FIG. 5

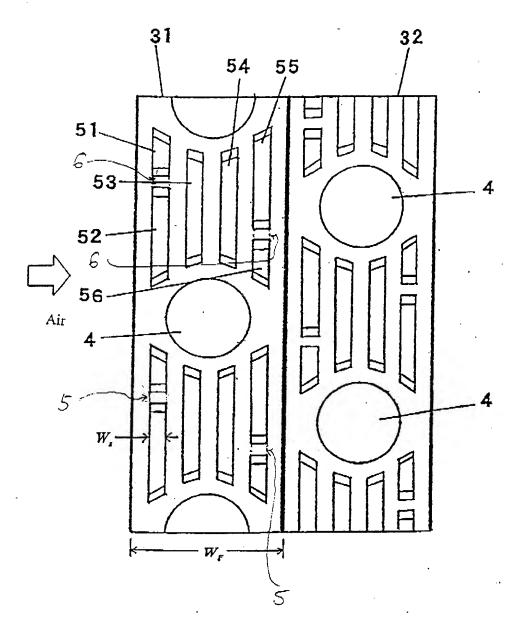
Also please add a new drawing Fig. 5.
